ECE/TRANS/WP.15/AC.2/2008/3  
29 October 2007

Joint Meeting of Experts on the Regulations annexed to the  
European Agreement concerning the International Carriage  
of Dangerous Goods by Inland Waterways (ADN)\*

**PROPOSALS FOR AMENDMENTS TO THE REGULATIONS  
ANNEXED TO ADN\*\***

**Protection of the aquatic environment**

**Figure 2.4.4.2: Tiered approach to classification of mixtures for acute and chronic environmental hazards**

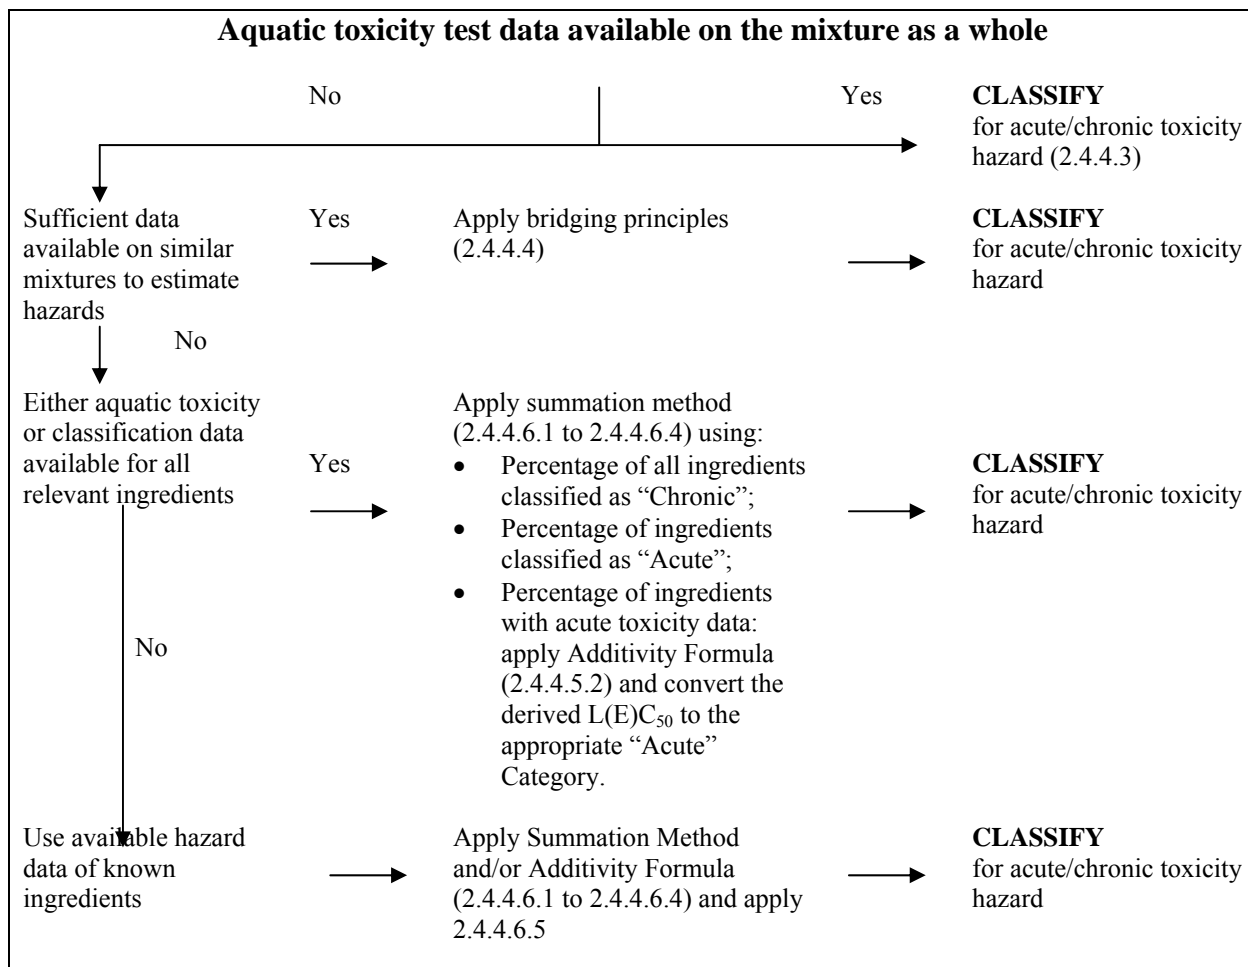
**2.4.4.2** The approach for classification of aquatic environmental hazards is tiered and is dependent upon the type of information available for the mixture itself and for its ingredients. Elements of the tiered approach include:

- (a) Classification based on tested mixtures;
- (b) Classification based on bridging principles,
- (c) Use of ‘summation of classified ingredients’ and/or an ‘additivity formula’.

Figure 2.4.4.2 outlines the process to be followed.

### Flowchart for classification of liquids of Classes 3, 6.1, 8 and 9 for carriage in tanks in inland navigation

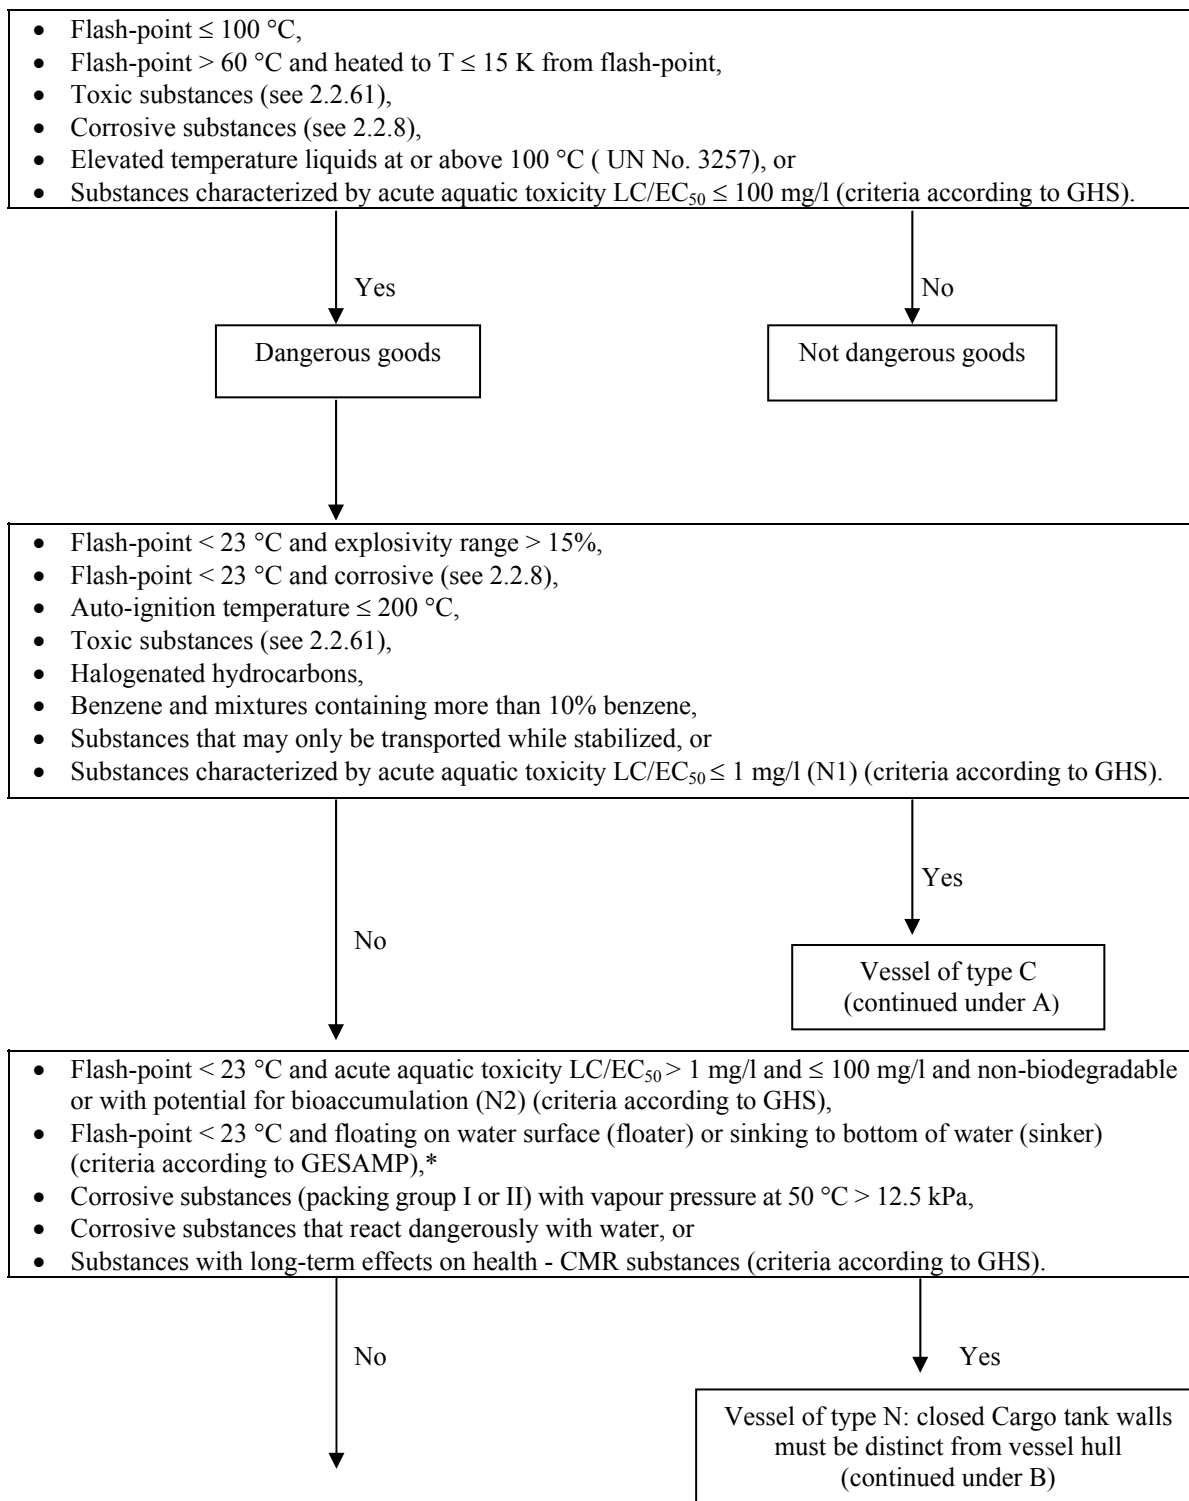
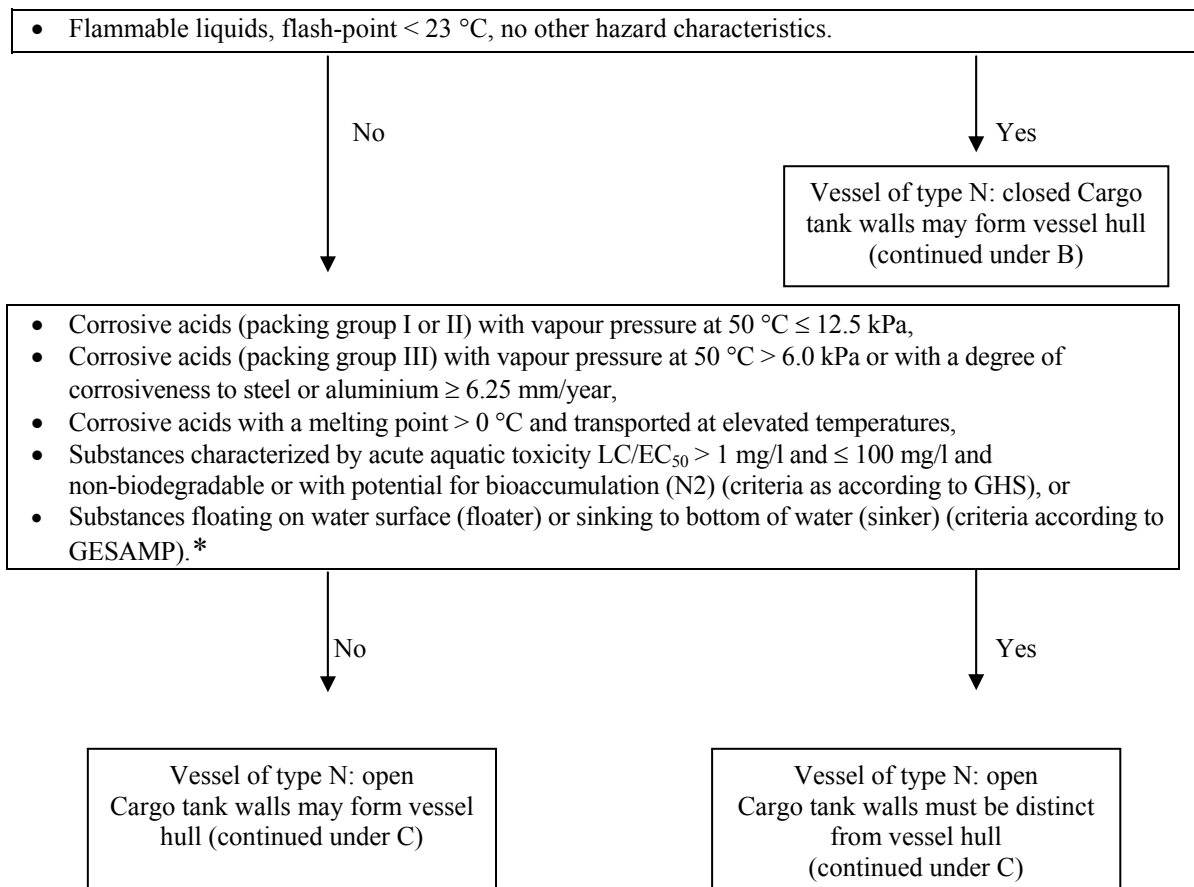
14. Add the following flowchart after Table C:
